We are grateful to both referees for thorough evaluation of our manuscript. Our responses to the comments are detailed below. Please note that *the referee's comment* and our responses are in different styles. The page and line numbers shown below correspond to those in the revised manuscript.

Referee 1

The manuscript presents a methane source characterization in the Tokyo area using mobile measurements of CH₄ and C₂H₆. Although this technique is not novel, this is the first study of its kind in the Tokyo area. It is very interesting to see a comparison with other major cities, where most CH₄ sources are of fossil origin, while in Tokyo biogenic sources seem to be more important. The manuscript is generally well written, and the instrument characterization is well detailed. However, I find the emission quantification method not sound, due to the issues related to the height of the emission release, the distance from the source and different wind conditions, which affect gas dispersion. I am not sure that, given the different meteorological and sampling conditions during the sampling campaigns, it is possible to quantify areal emissions by using the equation yielded during the con

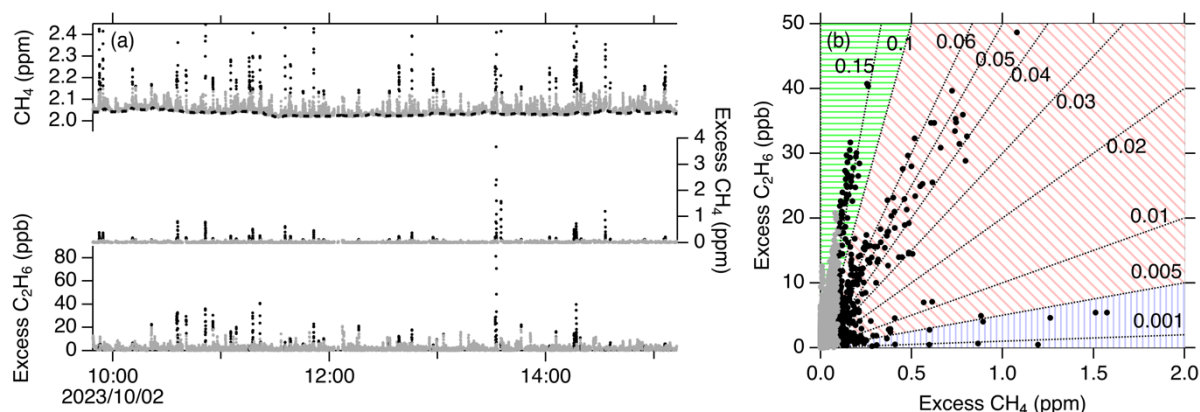
Figure 4 (b): could you change the colors of red lines according to the source category (e.g. fossil, biogenic and combustion)?

We have corrected the figure as attached below so that readers can visually understand the source categories. The figure caption was modified accordingly.
